RE: MDP 837 Pioneer Meadows

MASTER DEVELOPEMENT PLAN

Re: Pioneer Meadows Subdivision

MDP # 837

PIONEER MEADOWS
 MASTER DEVELOPEMENT PLAN

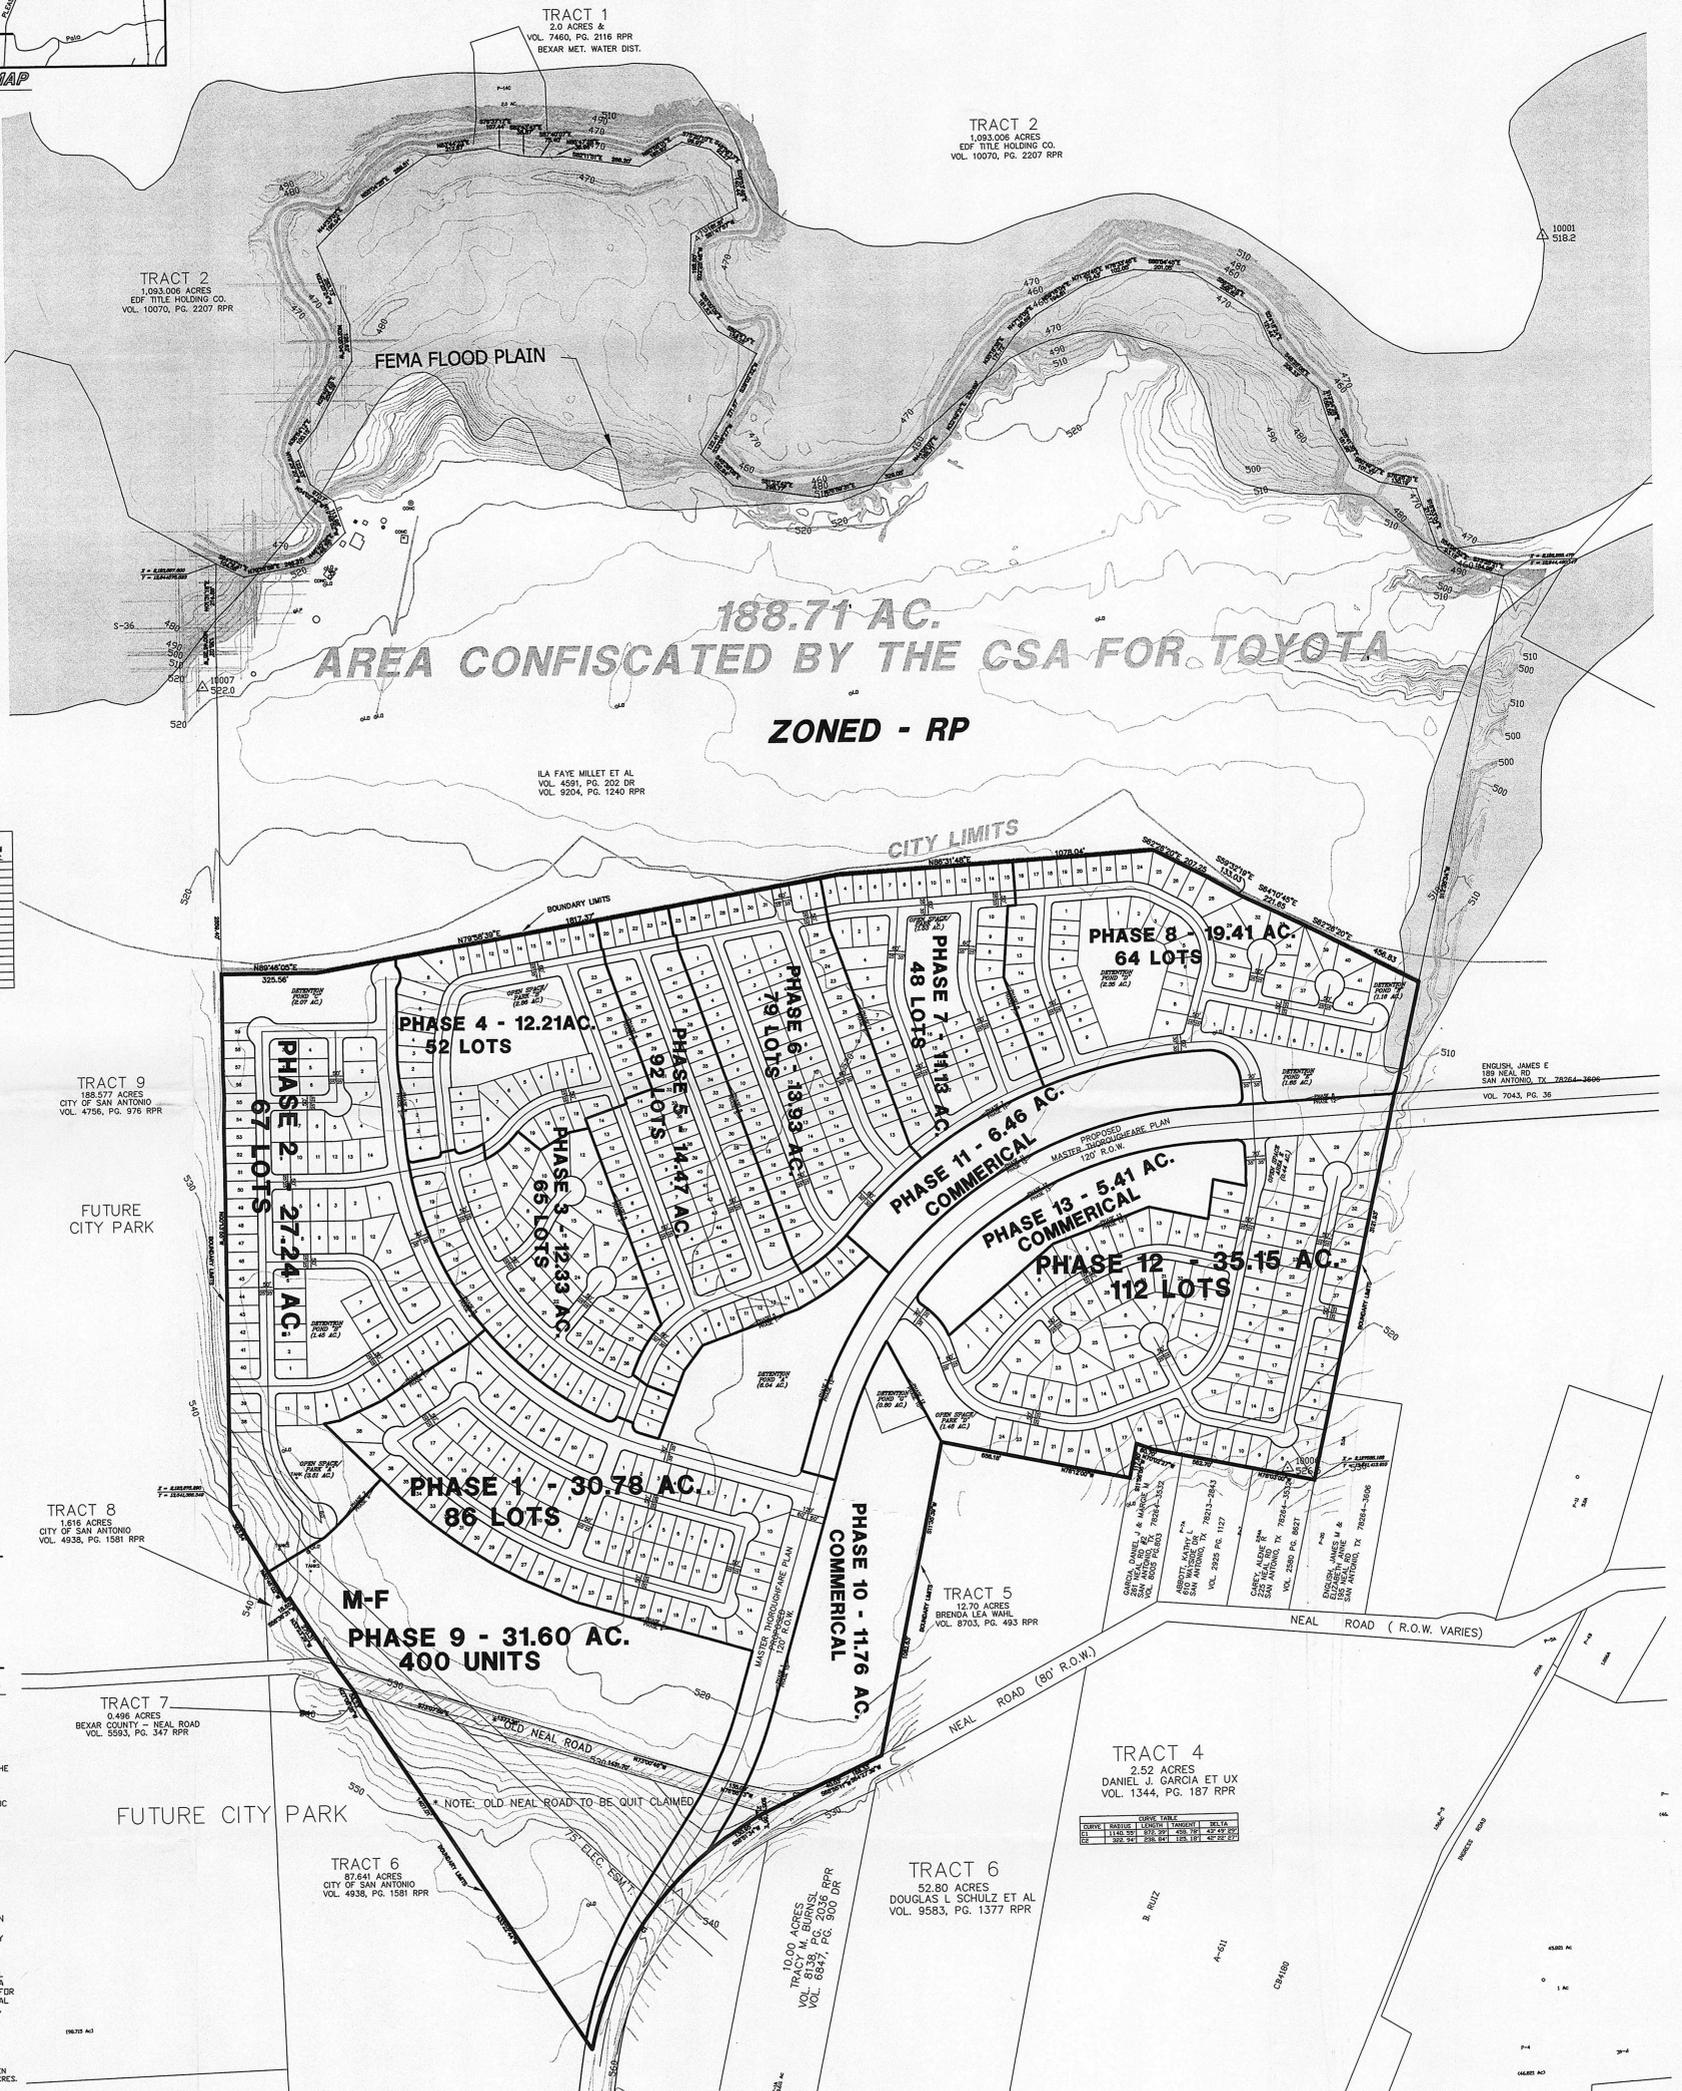
- In consideration of public safety and convenience, excessive grades by reason of topography should be avoided in street layouts and arrangements.
- The acceptance of this Master Development Plan # 837 is confined to the boundary limits of the site. Any projection(s) of future roadways outside the boundaries does not infer any set alignment of future roadways. All major arterials and streets shall follow all regulations.

- Any access and R.O.W. issues along state facilities will need to be resolved with the Texas Department of Transportation (TXDOT). For information about these requirements you can contact TXDOT at 615-5814.

- The information submitted for the above-referenced request has been reviewed by the San Antonio Historic Preservation Office (HPO) staff according to the city's Historic Preservation and Design Section of the Unified Development Code. (Article 6 35-630 to 35-634) We believe that cultural resources exist within the project area that should be documented before the project moves forward.

1. All roadways shall follow Table 506-7, Functional Classification System Description and shall comply with UDC 35-502(a)(9).
2. All access roadways shall provide clear sight distance on all existing and proposed roadways in order to provide adequate obstruction free viewing distances for approaching traffic. All signage, landscaping, and improvements shall be selected and located so as to not block these clear sight distance areas.
3. The developer shall be responsible for providing right-turn deceleration lanes as well as left turn lanes, with storage lengths and bay taper as it relates to the submitted TIA traffic counts, (Uniform Development Code (UDC) - 35-502 (a)(7), subsection C.

It should be understood that the submitted TIA concurrent with the proposed Pioneer Meadows is a conceptual plan and therefore this document does not represent an approval for the internal street plan. All streets and driveways shall follow UDC 35-506 and the street network shall be planned in order to provide safe and efficient movement of traffic to and from, within and past, the proposed development, while minimizing the impact to non-site trips. UDC 35-506 will be implemented at the time of platting.

1. Detention pond to include landscaping for aesthetics
2. Buffer included between residential and multi-family and commercial development
3. Pedestrian access to retail development

1. Neal Road will be extended north through this development as an Enhanced Secondary Arterial with 120 feet ROW.
2. The existing westbound Neal Road will be realigned into the Enhanced Secondary Arterial, creating a perpendicular T-intersection.
3. Care should be taken in the final design in order to reduce long residential streets which may encourage speeding.
4. All traffic controls shall be warranted as per the Texas Manual on Unified Control Devices and approved by Bexar County or the City of San Antonio.

It is understood that this MDP is a conceptual plan and controlled access should be maintained in order to uphold safe and efficient traffic flow. Therefore, the developer of this property is encouraged to design common access and shared driveways between all proposed commercial lots. Bexar County reserves the right to address driveways, street design, sight distance, ADA requirements, drainage and floodplain issues at time of platting.
